**Work Order ID 83804**

Item Name: Crosstube Turning Detail

DRAWING NO. REV. F  
D407-667-245 SHEET 1 OF 4  
TITLE SCALE  
CROSSTUBE ASSY (407 HIGH AFT) NTS

DRAWING NO. D407-667-245	TITLE CROSSTUBE ASSY (407 HIGH AFT)	REV. F	DART AEROSPACE LTD ENGINEERING ORDER		D.E.O. NO. D407-667-245-F-1	SHEET NO. SHEET 1 OF 2	SCALE NTS
DRAWN	CHECKED	MFG. APPR.	APPROVED	DE APPR.			
DATE 11.04.08	DATE 11.04.12	DATE 11.04.12	DATE 11.04.12	DATE 11.04.12

DRAWING NO. D407-667-245	TITLE CROSSTUBE ASSY (407 HIGH AFT)	REV. F	DART AEROSPACE LTD ENGINEERING ORDER		D.E.O. NO. D407-667-245-F-1	SHEET NO. SHEET 2 OF 2	SCALE NTS
DRAWN	CHECKED	MFG. APPR.	APPROVED	DE APPR.			
DATE 11.04.08	DATE 11.04.11	DATE 11.04.12	DATE 11/04/12	DATE 11.04.12

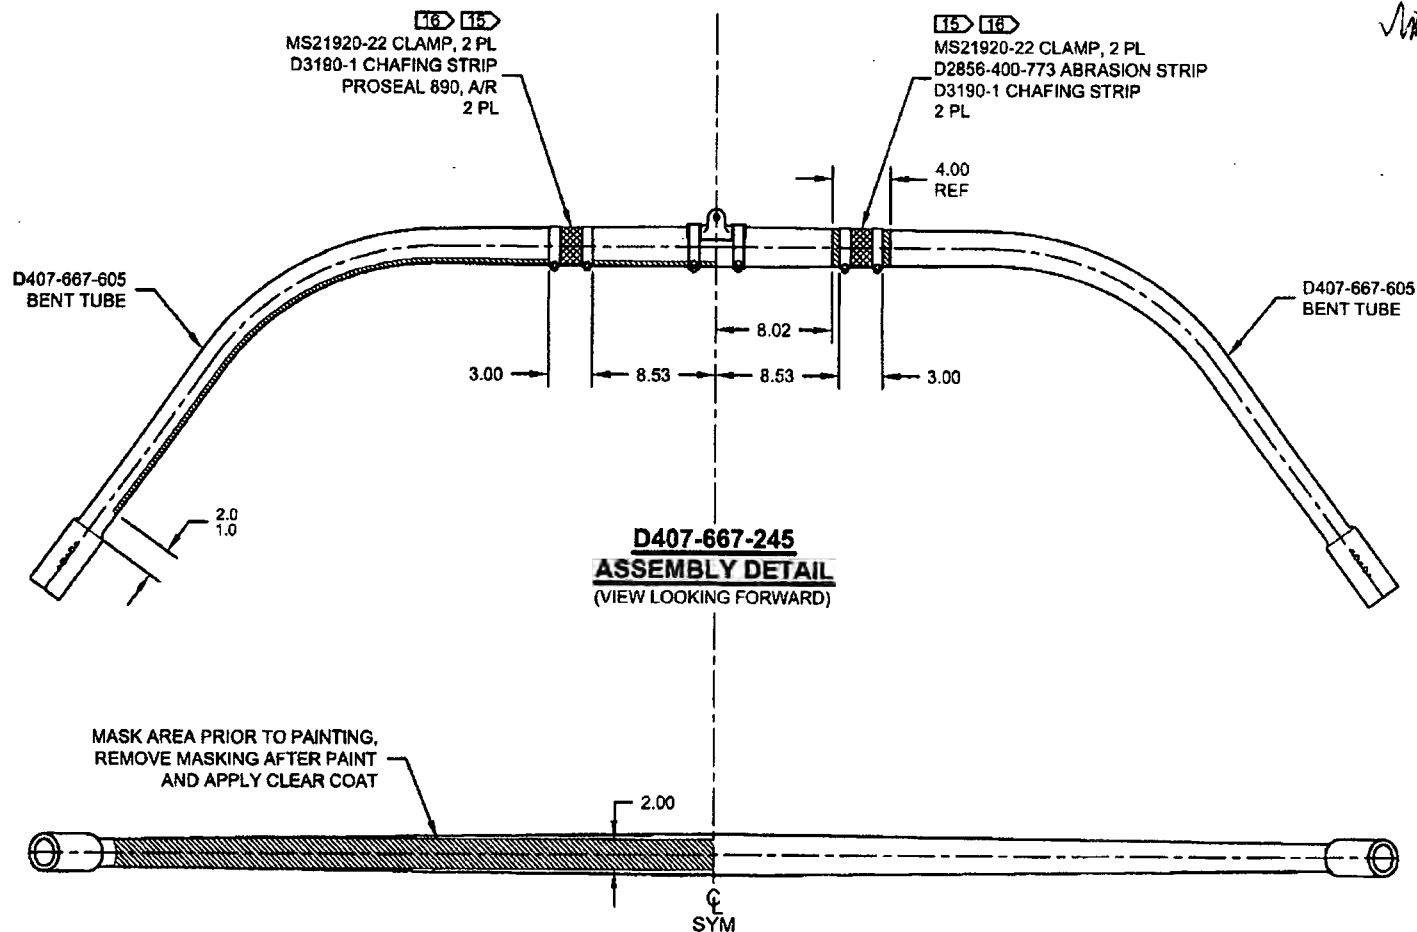
**PURPOSE:**

REMOVED ABRASION STRIP IN FAVOR OF A THIN LAYER OF PROSEAL 890.

NOTES 2 AND 15, SHEET 1 ARE AMENDED AS FOLLOWS:

- 2) FINISH: CHEMICAL CONVERSION COAT PER DART QSI 005 4.1  
PRIME INSIDE AND OUTSIDE PER DART QSI 005 4.2  
MASK UNDERSIDE OF CROSSTUBE AS SHOWN (HATCHED AREA) AND  
PAINT OUTSIDE PER DART QSI 005 4.2  
REMOVE MASKING AND APPLY CLEAR COAT
- 15) APPLY A THIN COAT OF PROSEAL 890 ON INSIDE CONCAVE SURFACE OF D3190-1  
CHAFING SHIELDS AND LET CURE PER MANUFACTURER'S INSTRUCTIONS. INSTALL  
PROSEALED D3190-1 CHAFING SHIELDS ONTO CROSSTUBE BY APPLYING A THIN COAT  
OF PROSEAL 890 ONTO CROSSTUBE. BE SURE TO ELIMINATE ANY AIR GAPS.

- 2) FINISH: CHEMICAL CONVERSION COAT PER DART QSI 005 4.1  
PRIME INSIDE AND OUTSIDE PER DART QSI 005 4.2  
PAINT OUTSIDE PER DART QSI 005 4.2
- 15) INSTALL D2856-400-773 ABRASION STRIP WITH A 0.13 REF GAP ON BOTTOM SIDE OF  
CROSSTUBE PER QSI 035.

DRAWING NO. D407-667-245	TITLE CROSSTUBE ASS'Y (407 HIGH AFT)	REV. F	DART AEROSPACE LTD ENGINEERING ORDER		D.E.O. NO. D407-667-245-F-2	SHEET NO. SHEET 1 OF 1	SCALE NTS
DRAWN 92	CHECKED ASS	MFG. APPR. E	APPROVED MP		DE APPR. H		
DATE 11.09.07	DATE 11.09.19	DATE 11.09.19	DATE 11.09.19		DATE 11.09.19

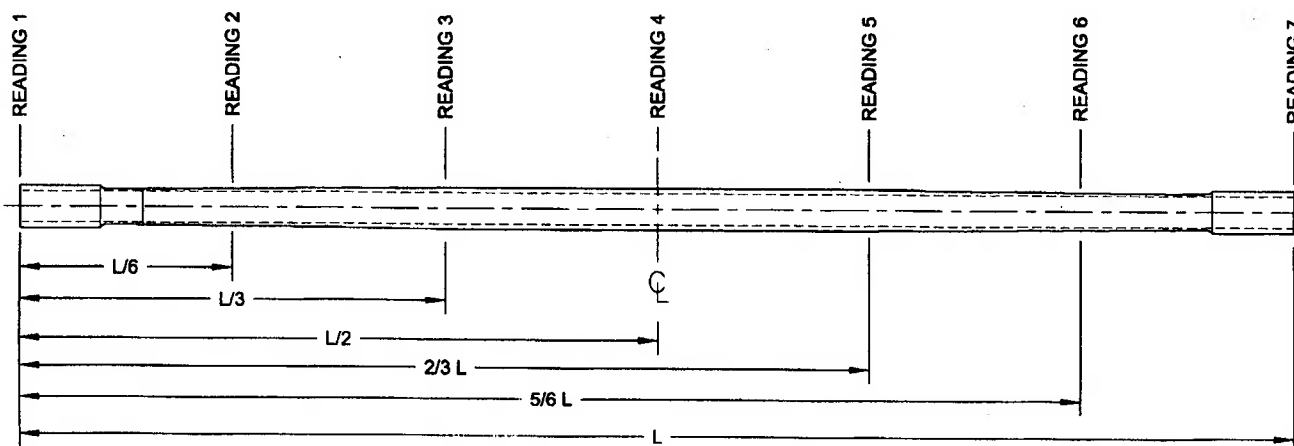
**PURPOSE:**

REPLACE MAGNOBOND WITH 3M DP460 SCOTCH-WELD EPOXY ADHESIVE

NOTE 12 & 17, SHEET 1 IS AMENDED AS FOLLOWS:

- 12) INSTALL D2894-1 CENTER SUPPORT USING A 0.04" TO 0.07" THICK LAYER OF SCOTCH-WELD DP460 PER QSI 015. LET CURE FOR 24 HOURS AFTER INSTALLATION AND PRIOR TO PACKAGING.
- 15) TORQUE CLAMPS 80 TO 100 IN-LB. ENSURE AT LEAST 1.5 THREADS SHOWING IN SAFETY AND THAT NUT HAS NOT BOTTOMED-OUT AFTER TORQUING. PRIOR TO PACKAGING, RE-CHECK TORQUE ON CLAMPS AFTER ADHESIVE HAS CURED FOR 24 HOURS.

- 12) INSTALL D2894-1 CENTER SUPPORT USING A 0.03" TO 0.06" THICK LAYER OF MAGNOBOND 6398 PER QSI 015. LET CURE FOR 12 HOURS AFTER INSTALLATION AND PRIOR TO PACKAGING.
- 15) TORQUE CLAMPS 80 TO 100 IN-LB. ENSURE AT LEAST 1.5 THREADS ARE SHOWING IN SAFETY AND THAT NUT HAS NOT BOTTOMED-OUT AFTER TORQUING.
